Illinois Commerce Commission

Staff's Assessment Report of
Mt. Carmel Public Utility Company
2009 Reliability Report

July 12, 2011

Figure (12)
Tree contacts primary wire
(Circuit 21000-Photo 5)

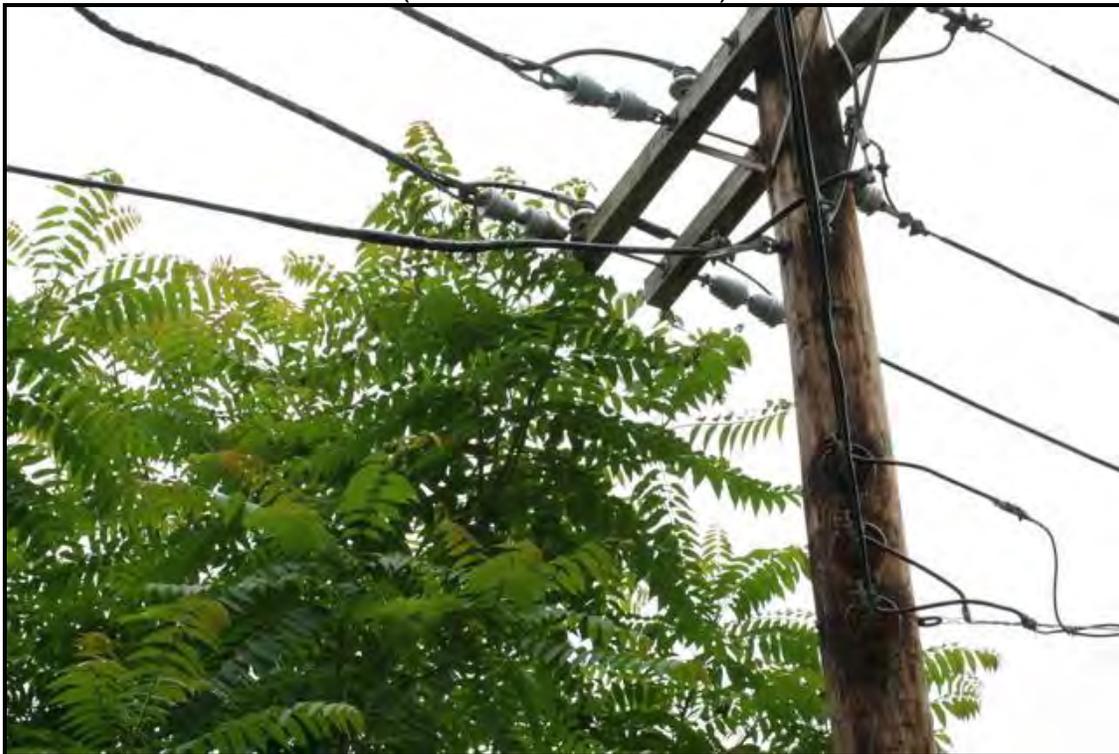
On June 9 and 10, 2010, Staff inspected Circuit 21000, known as Froman Drive Feeder, which serves predominantly rural parts of MCPU service territory. Circuit 21000 serves 1,099 customers at 12,470 volts. In 2009, MCPU reported Circuit 21000 as a next to worst SAIFI performing circuit at 1.12. MCPU reported Circuit 21000 as worst or next to worst SAIFI performing circuit from 2006 through 2009. Overall, the facilities of this circuit are in good condition. Lightning arrestors are adequately spread throughout the circuit. During Staff's inspection of this circuit, Staff recorded 77 observations that Staff believed might case a threat to reliability on this circuit. Fifty-five of those observations involved vegetation conflicts with overhead primary wires. Figures (12) through (16) are depictions of those situations.

Figure (28)
Split pole top (Circuit 22000-Photo 74)

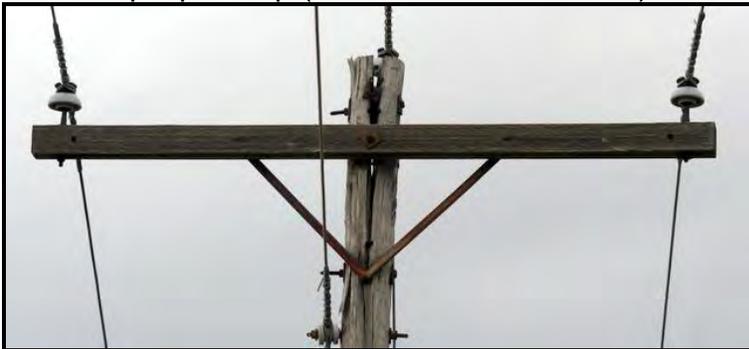
distribution poles, on down guys; and near primary wires and other equipment. Generally vegetation conditions in this circuit are relatively better than the other circuits that Staff inspected in 2010; however, more needs to be done in terms of vegetation management before the spring of 2011. Figure (28) is an example of those situations.
